The cable harness in the A-pillar can cause electrical faults

Scania

Fig. 1.

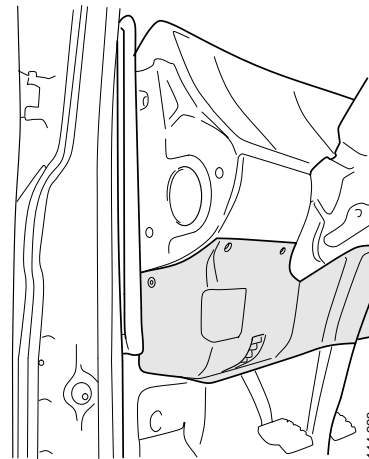
1. Remove the protection cover mounted against the A-pillar. See fig. 1.
2. Loosen the connectors mounted between the A-pillar and the instrument panel.
3. Relocate the cable harness from the upper, to the lower hole in the A- pillar. Tape the holes' edges to protect the cable harness.
4. Cut approx. 20 cm of the slotted protection hose.
5. Slide the protection hose over the cable harness and tape together the protection hose.
6. Re-connect the connectors.
7. Re-fit the protection cover, using the shorter screws.

Fig. 2.

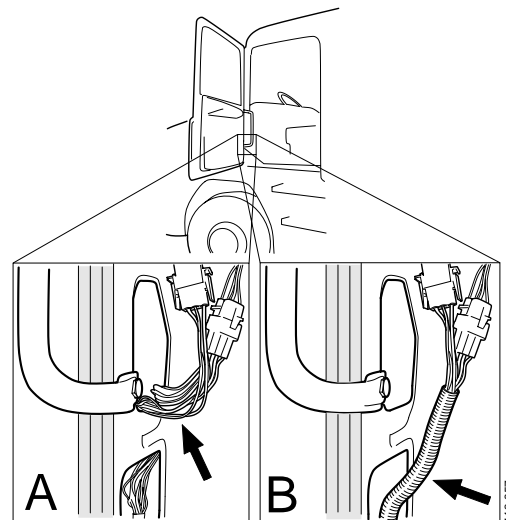
To protect the cable harness against damage, a protection hose is placed around the cable harness. At the same time, the screws for the protection cover are changed to a shorter length.

- A: Old version.
- B: New version.
